Addendum Date: September 25, 2025

CITY OF PENSACOLA, FLORIDA
ADDENDUM #1

**SOUTH PALAFOX PEDESTRIAN IMPROVEMENTS:
GARDEN STREET TO MAIN STREET**

Bid No. 25-045

C-103

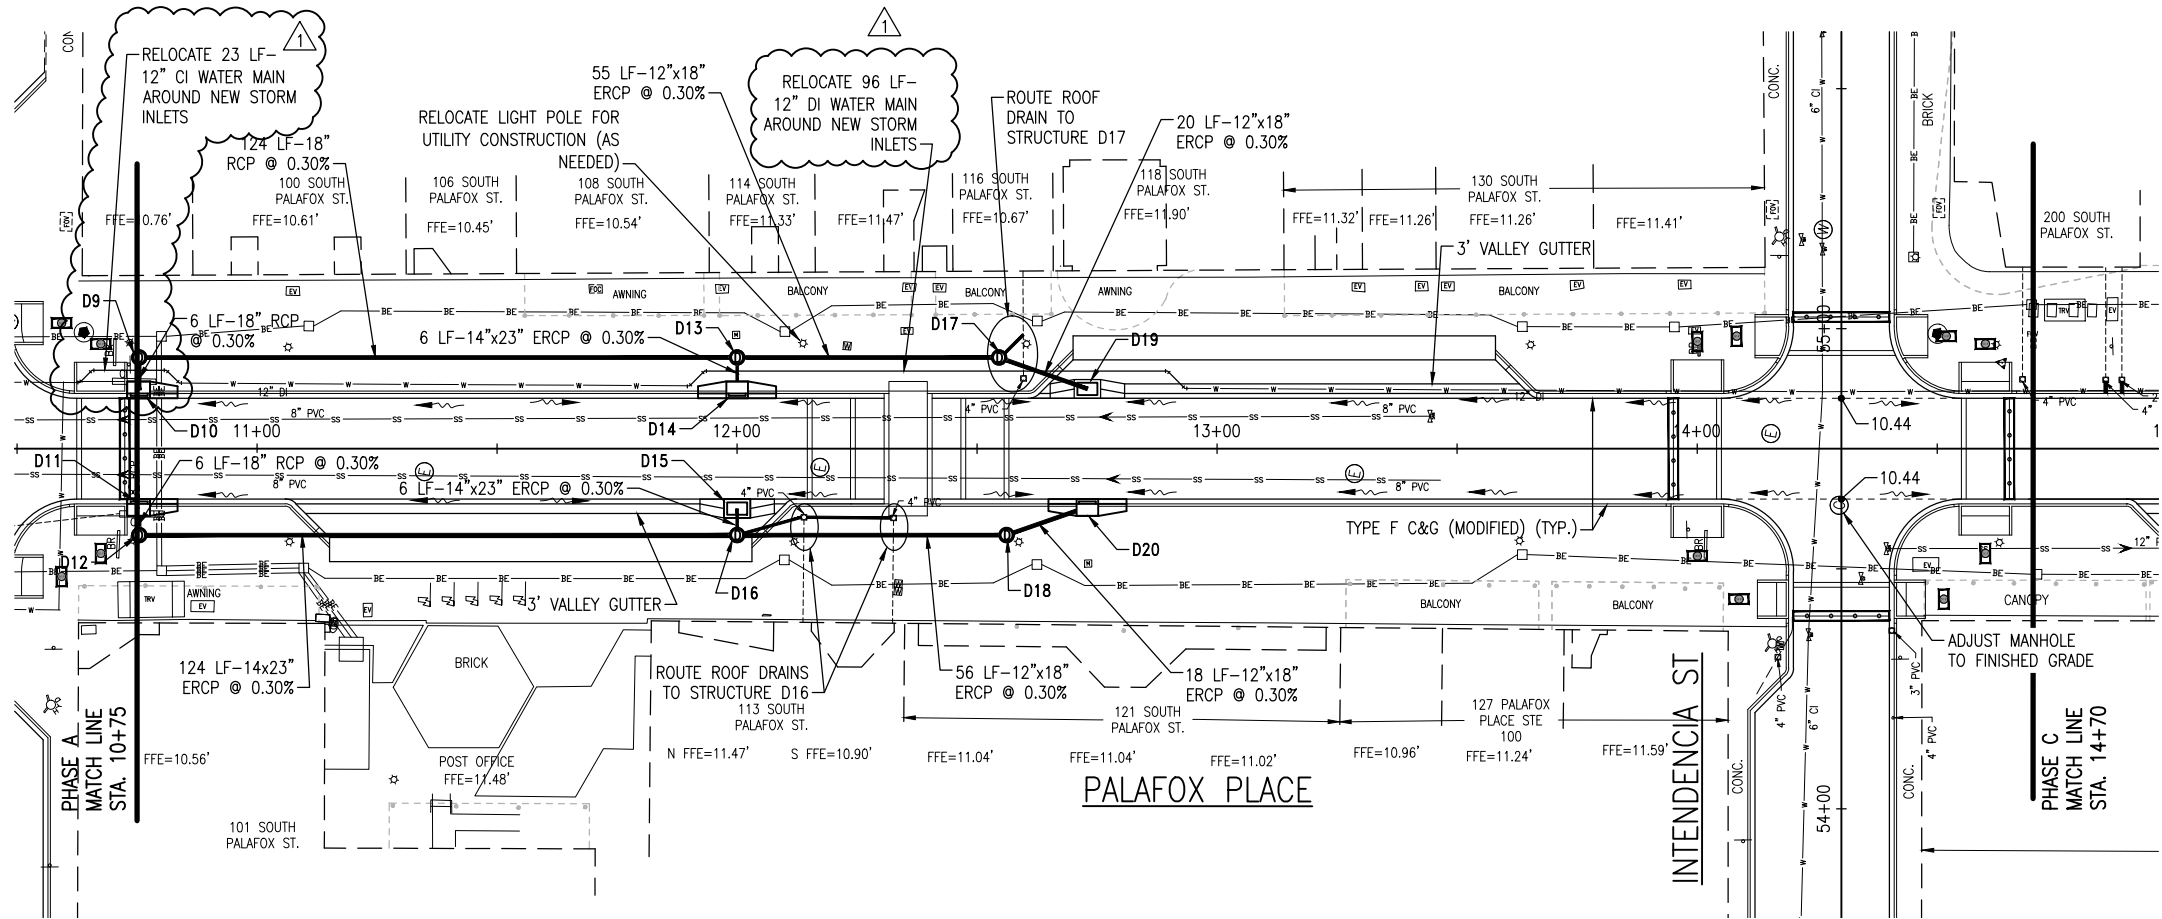
- Question: Are there any plans to relocate the water line around the pipe run from D5 to D-7?
 - Response: Sheet C-103 and the bid tabulation for 12" Water Relocate has been increased to 374 feet of relocation of 12" WM.

PROJECT NO.	DATE	APPR.	REVISION / ACTION	TAKEN
24324.01	08/24/25	JJF	REROUTE WATER MAIN	
DESIGNED BY: MDL				
DRAWN BY: RGG				
CHK'D BY: MDL				
PROJ. MGR: JJF				
DATE: AUG 2025

PALAFOX PLACE
DRAINAGE PLAN

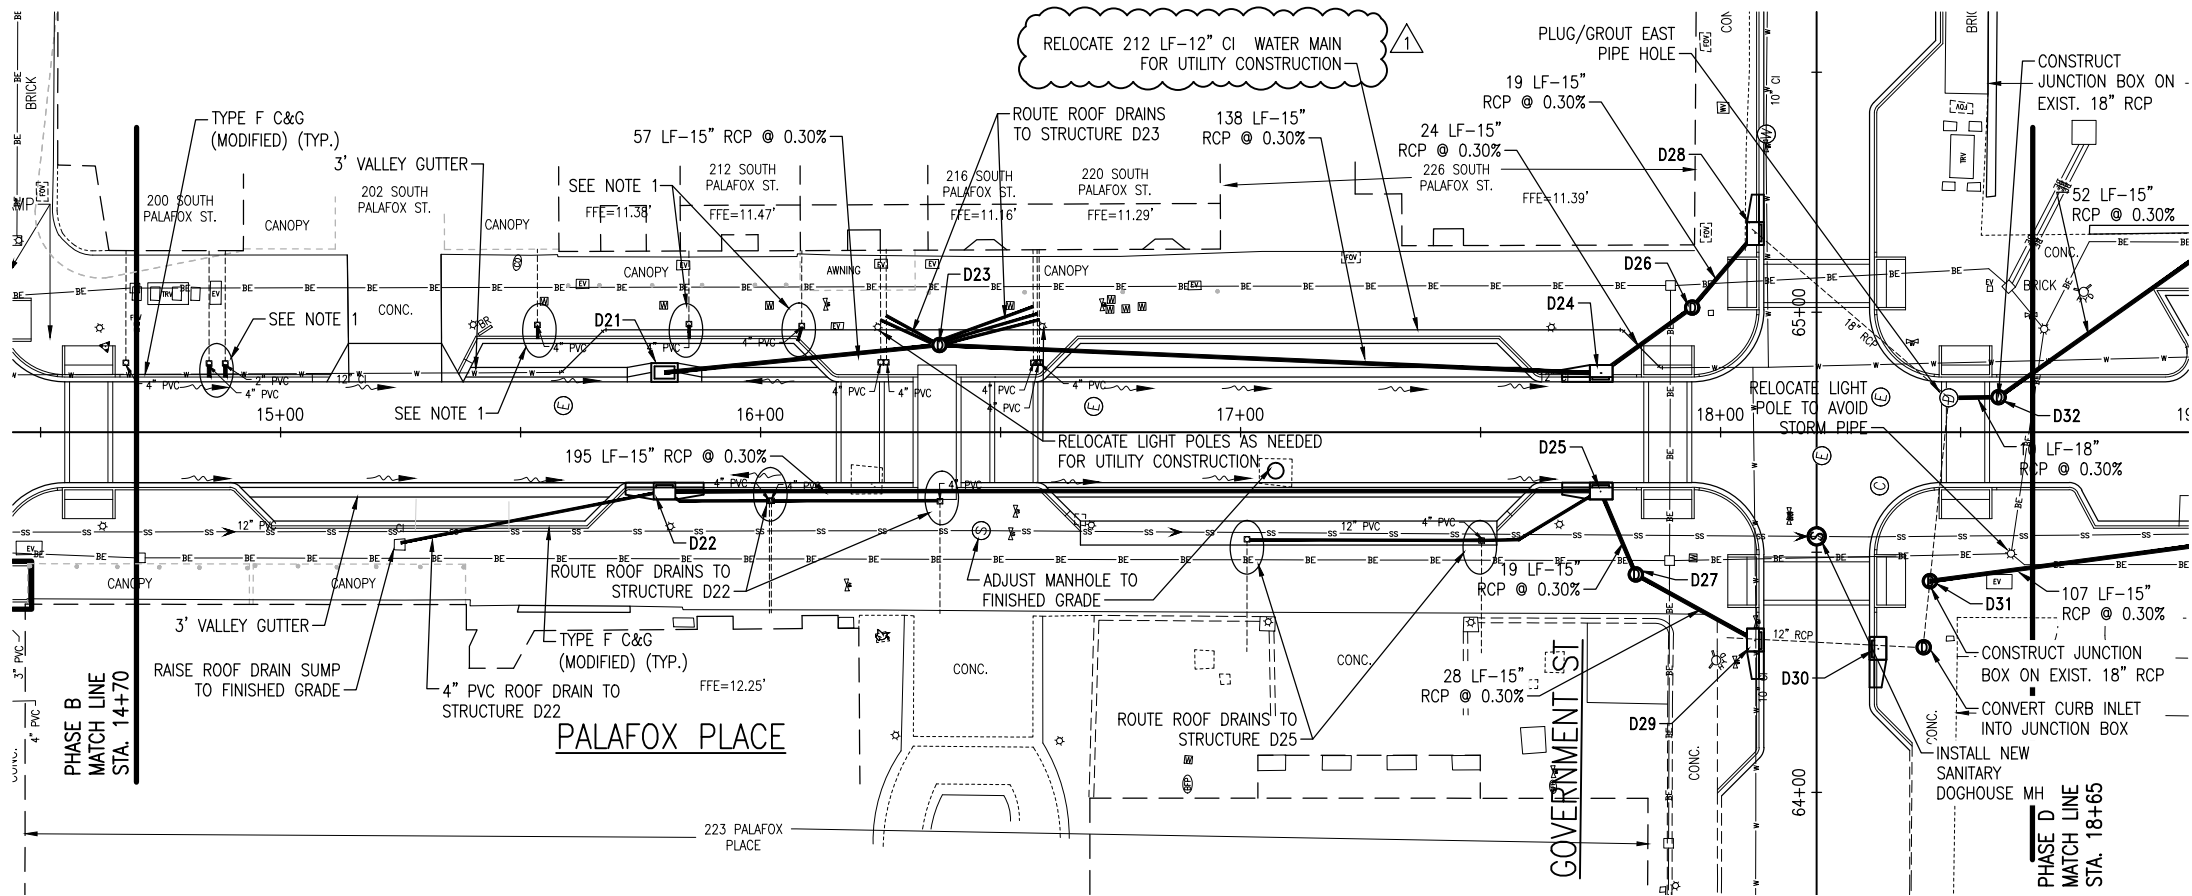
PROJECT NO.	NO.	DATE	APPR.	REVISION/ACTION TAKEN
24324.01	1	08/24/25	JJF	REROUTE WATER MAIN
